Office Action Summary	Application No. 10/521,740	Applicant(s) GLAUBITZ, ROBERT MANFRED	
	Examiner Mr. Terry K. Cecil	Art Unit 1723

DETAILED ACTION

FIG.II

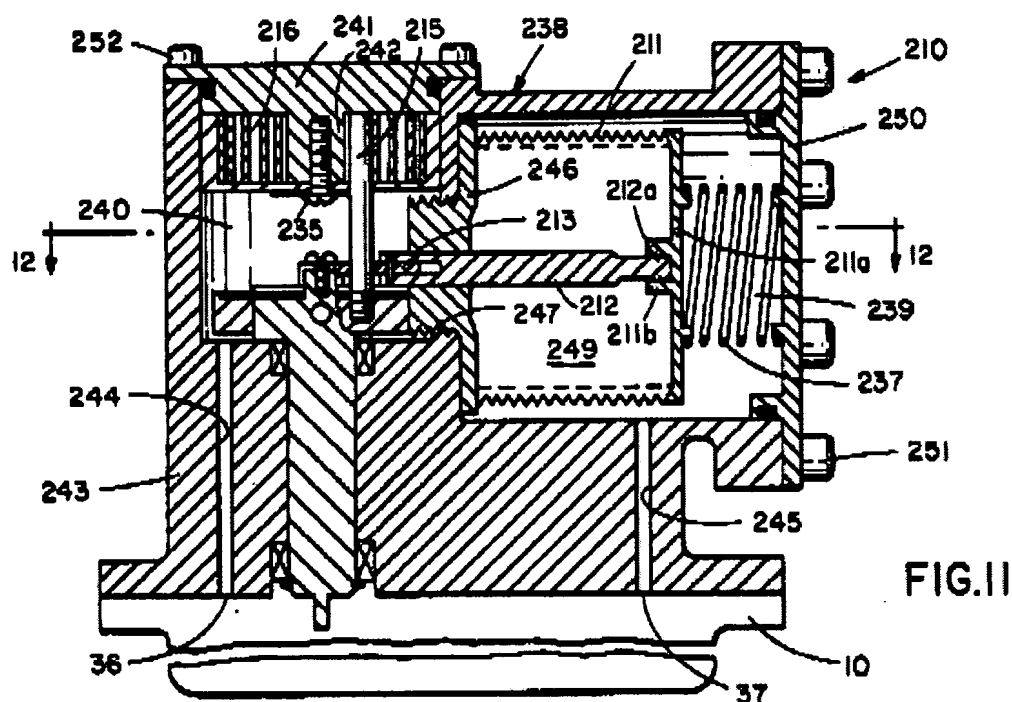
8. Claims 1, 12 and 14 are rejected under 35 U.S.C. 102(b) as being clearly anticipated by Winzen (U.S. 4,054,521).

See also cols. 7-8 and figures 12-15.
